Subject: TeamPoS 3000 XL Printer Problems

Overview

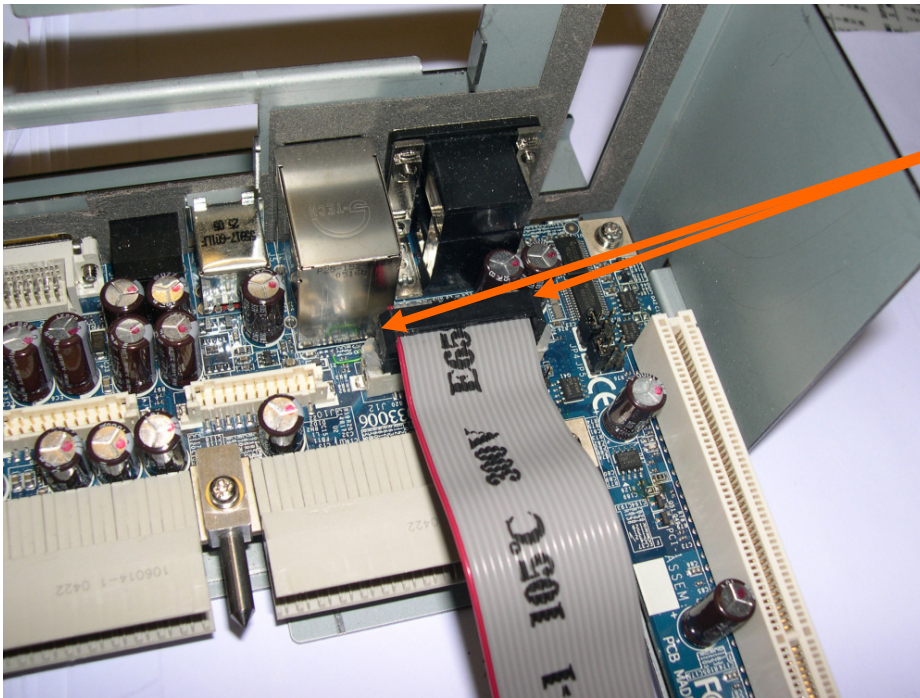
1. When equipped with a Combo board (Intelligent PIN = XMXX3XXXXXXXXXX), the printer may become intermittent as a result of a loose connection on the docking backplane. This is because the cable going from J12 on the docking backplane to the combo board may work itself loose in shipment or handling. See picture below.
2. When the Combo board does not have the jumper pack PRT1-7 jumpered for the correct printer (RS-232 interface)
3. When replacing a DT50III printer with a DT50II printer the OPOS settings will point to the wrong printer.

1. To insure the cable does not work loose during shipment an EC has been generated to apply a RTV silicon adhesive during manufacture. This should not affect existing terminal that have been installed for more than two weeks, but it is something to check for in case the terminal is showing intermittent printer problems. See attached pictures for the EC.

RTV
adhesive
applied
here
